**RE: DA2022/1619 – 65 Dolphin Crescent, Avalon Beach – Request for Information**

I refer to your letter, dated 6 December 2022, relating to the abovementioned DA. This letter is supported by an amended set of architectural plans, prepared by Giles Tribes Architects, Rev F, dated 22 December 2022.

**Figure 1.** 3D 8.5m building height blanket (Source: Giles Tribe Architects)

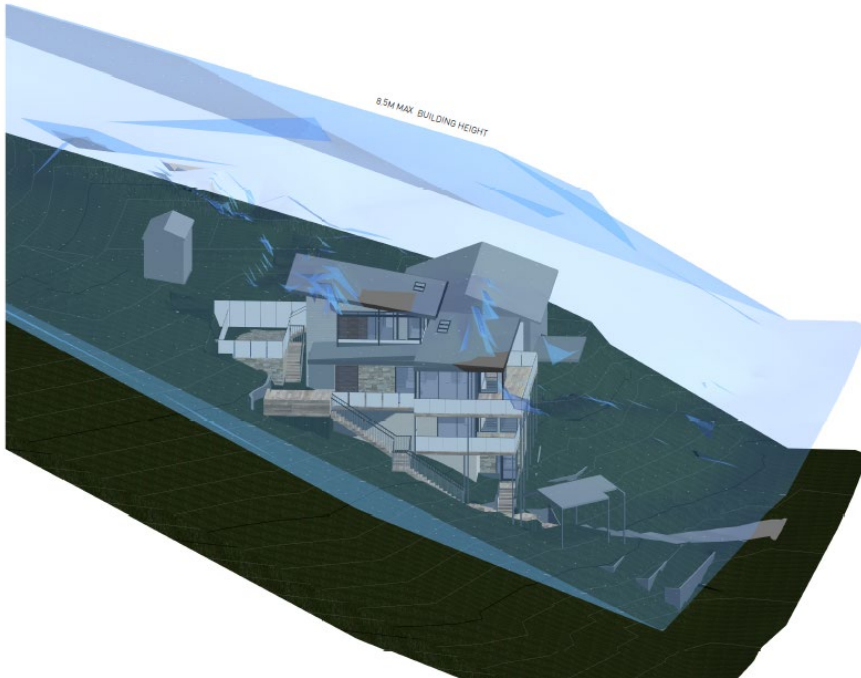
The plans, as amended, while numerically non-compliant, consist entirely of roof structure over the existing balcony on the ground floor. However, the extent of encroachment at the first floor comprises a minor component of internal floor area (4sqm), but the encroachment consists of the roof in this area (refer to **Figure 2**). As such, the portion of the dwelling above the maximum building height control is found to be minor and consistent with subclause (2D)(a).
